The Center for
Environmental Law & Policy

Re: 401 Certification Comments Re Aesthetic Flows

The Center for Environmental Law & Policy and Sierra Club Upper Columbia River Group submit these comments on the aesthetic flow conditions contained in the draft 401 Certification for Avista Corp.'s Spokane River Project. We plan to submit additional comments on other provisions of the draft 401 document, but wish to get these to you promptly for your consideration.

Upper Spokane Falls average rankings and percent ranking flow "most preferred." (See Att. 3, p. 6).

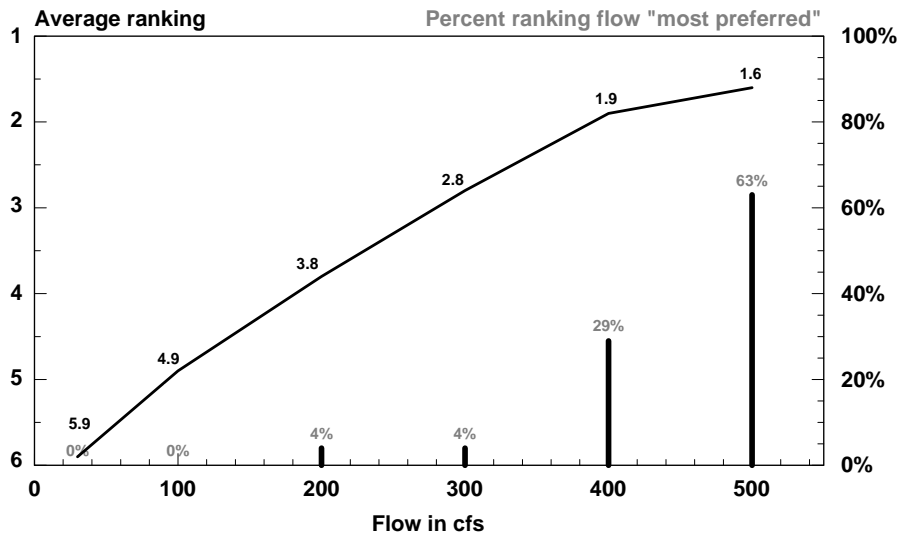
The Louis Berger study is frequently cited as the basis for a finding that 200-300 cfs is the preferred flow among study respondents. This is incorrect and in fact, Table 2.14 (p. 32) in the Louis Berger study sets forth the results of the survey showing that the highest flow viewed by respondents – 500 cfs – is the preferred flow. That table shows the average ranking of flows from a scale of 1 to 6 (1 being the most preferred flow and 6 the least preferred). See Attachment 4 (Louis Berger study excerpt). Flows at 500 cfs were ranked at 1.63 and all lower flows received higher rankings (ie, rankings that they were less preferred).

The Confluence Consulting Report provides an easier to read chart of the results of these rankings.

For the Upper Falls (Figure 1, next page), results show that the two highest study flows (400 and 500 cfs) are ranked highest. With the exception of two people, all the respondents ranked 400 or 500 cfs as most preferred, and nearly two-thirds ranked 500 cfs best. It is possible that higher flows would have been ranked even higher.
